ADDENDUM NO. 1

August 3, 2018
223490

**RE: PEACHAM FIRE DISTRICT 1
WATER SYSTEM IMPROVEMENTS**

FROM: DuBOIS & KING, INC.
P.O. Box 339
Randolph, Vermont 05060
(802) 728-3376

SHEET NUMBER
C13

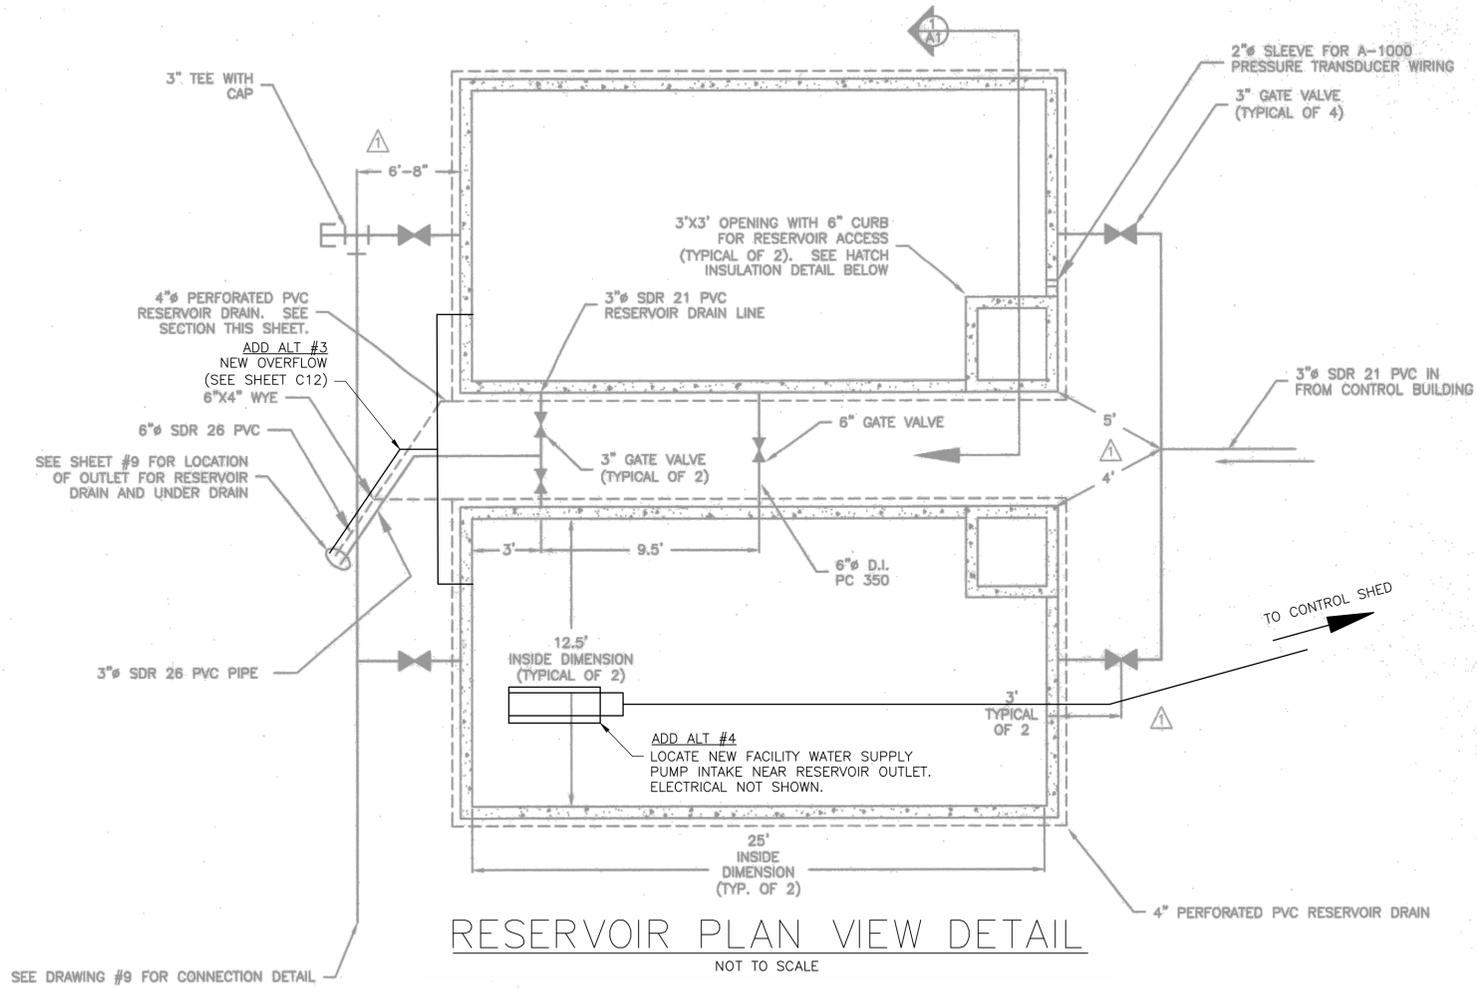
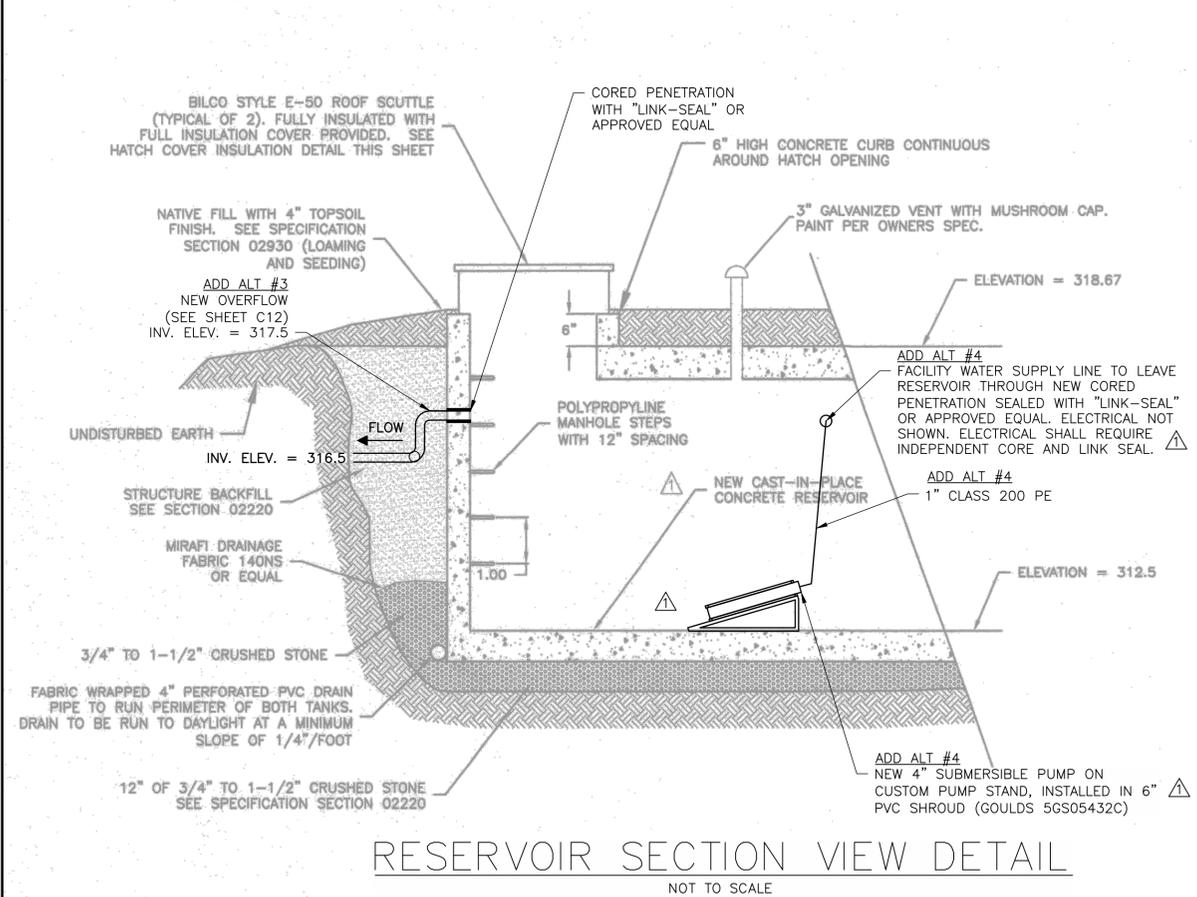
REVISED sheets C13 and C14 are included as part of this Addendum and replace the corresponding original sheets in the Bid Documents.

Question 1: Is there any further definition of the SCADA/control modifications beyond the notes on the plans?

Answer 1: Additional information has been provided on the attached revised Sheets C13 and C14.

C14

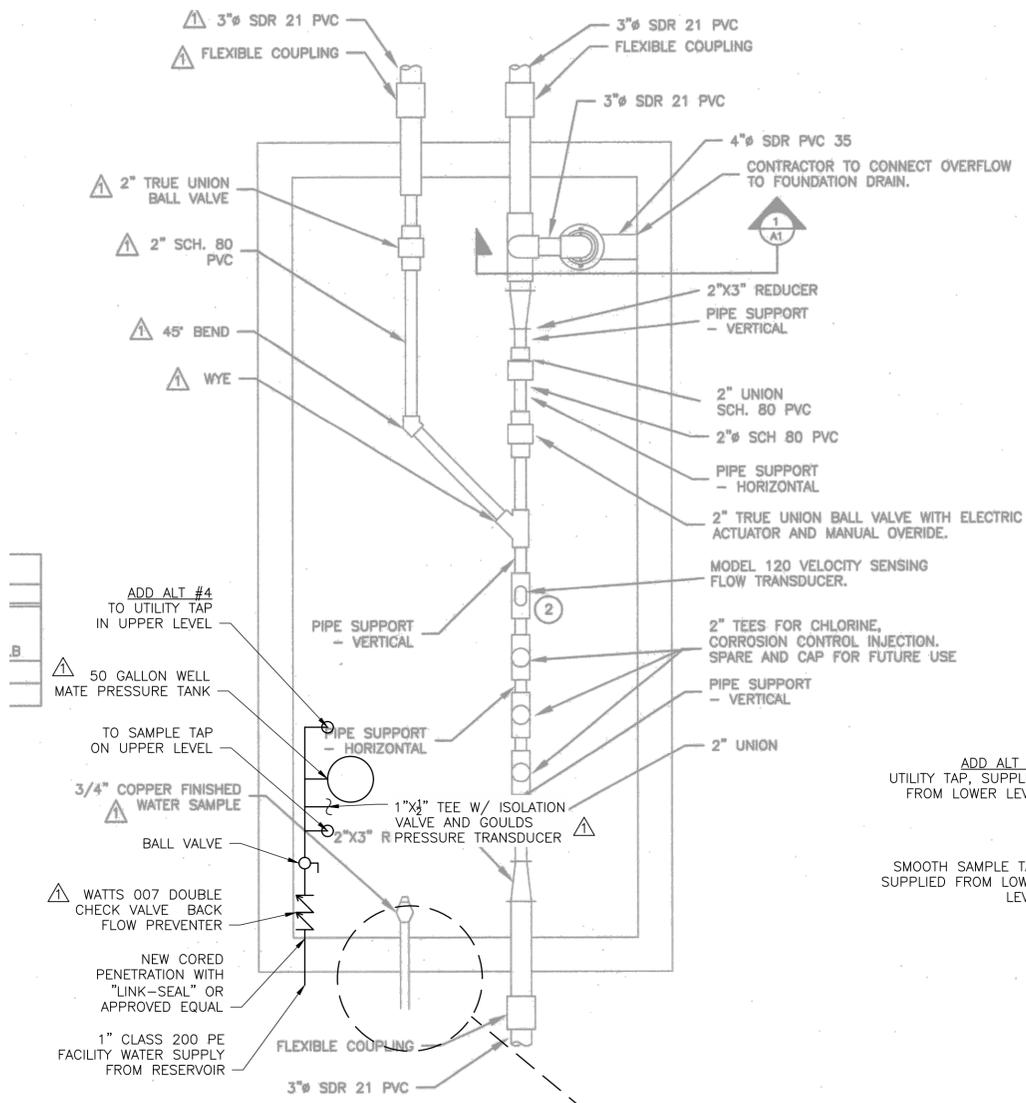
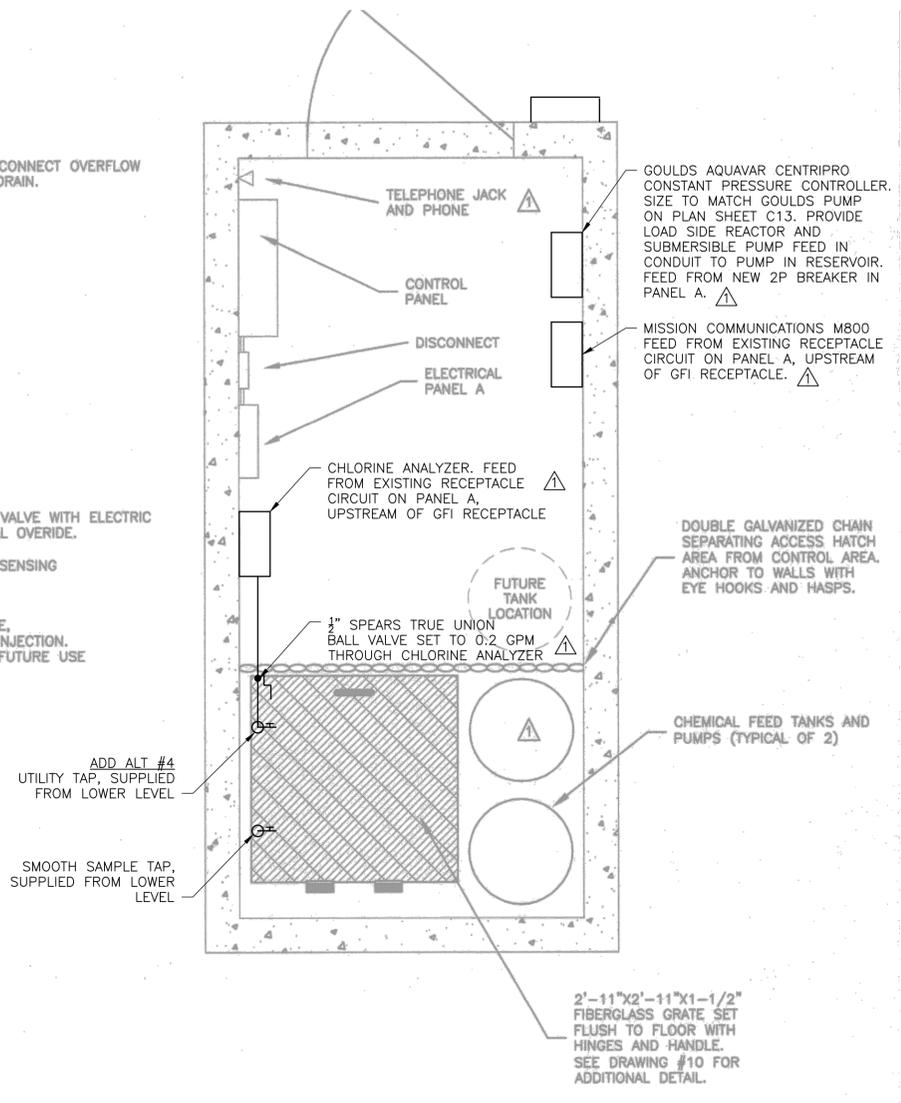
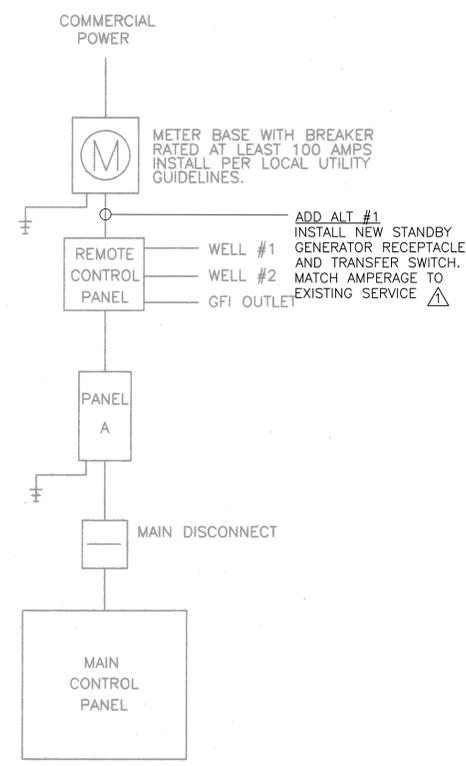
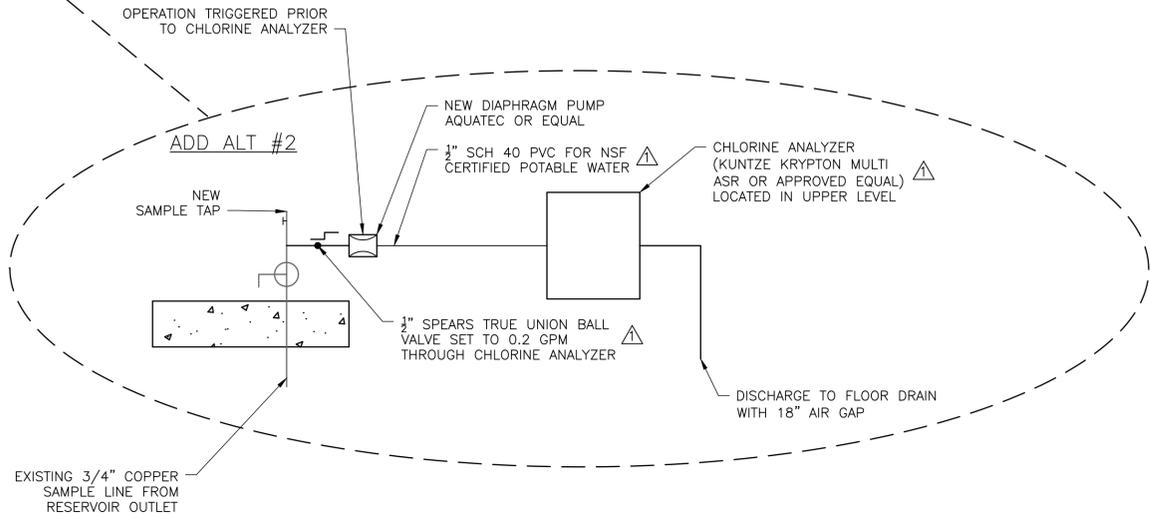
Question 4: Where is the Chlorine Monitor installed?

Question 5: Where is the Mission control panel installed?

Answer 4: See the attached revised Sheet C14.

Answer 5: See the attached revised Sheet C14.
